Re: Docket ID NRC-2019-0026, Red Water Pond Road Community Association  
Comments on Waste Consolidation Draft Environmental Impact Statement [License No.  
NUREG-2243]

Please accept the following comments on behalf of the members of the Red Water Pond Road Community Association ("Community") on the U.S. Nuclear Regulatory Commission's ("NRC") Draft Environmental Impact Statement for the Disposal of Mine Waste at the United Nuclear Corporation ("UNC") Mill Site in McKinley County, New Mexico NUREG-2243 ("DEIS").

Figure 3. Self-reported environmental exposures among Churchrock participants compared with All Chapters

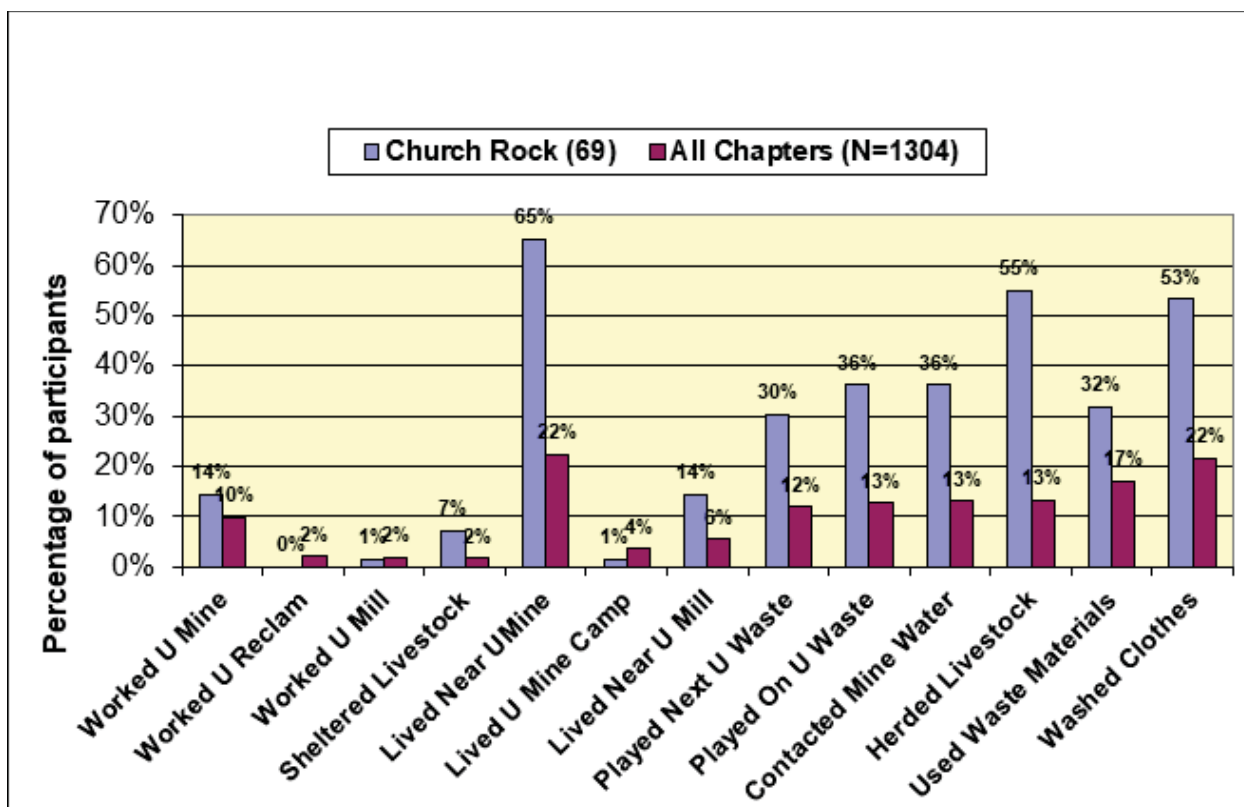
Between 2004 and 2011, the DiNEH Project conducted a water, land use and health survey among 1,304 residents of the Eastern Agency using Navajo-fluent and trained interviewers. In 2010-2011, the study hosted 14 community “collection events” at chapter houses, community centers and clinics at which 267 participants volunteered to provide blood and urine samples for analyses of metals and biomarkers of organ damage. Investigators ascertained exposure by calculating the distance from participants’ homes to 100 uranium waste sites (98 mines and 2 mill tailings facilities) and analyzing participants’ survey responses to 13 questions addressing how they may have been exposed in the past. Exposures range from working in mines, mills or on reclamation projects and living in mining camps to playing on waste piles, herding livestock on or near mine sites, and washing clothing of uranium workers. Nearly 200 participants were residents of Church Rock (69), Coyote Canyon (65) and Pinedale chapters (64) – three of the four chapters that span the Church Rock Mining District. Figure 3 shows that participants living in Church Rock Chapter generally reported more environmental exposures than all DiNEH participants, due largely to the fact that 20 abandoned uranium waste sites (19 mines and 1 mill) are located in the Church Rock area.

**Figure 4. Comparison of Prevalence rates for selected chronic diseases among DiNEH Project Participants, 2012 (from, Shuey, et al., 2019)**

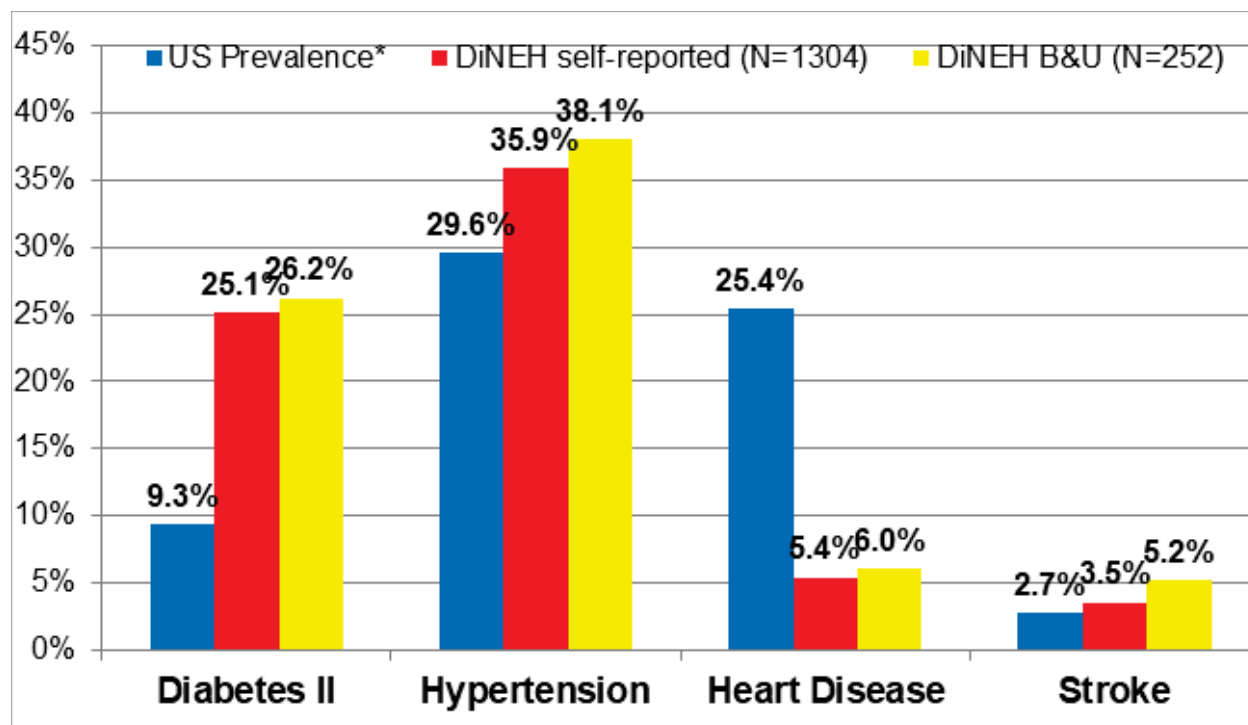
Self-reported and clinically established diseases among DiNEH participants compared with U.S. prevalence rates for key chronic diseases are shown in Figure 4. Prevalence of high blood pressure, diabetes and stroke was greater than U.S. rates; heart disease was one-fourth of the U.S. prevalence rate. UNM researchers applied advanced analytical methods to the survey, geospatial and biological data. Among the salient findings were:
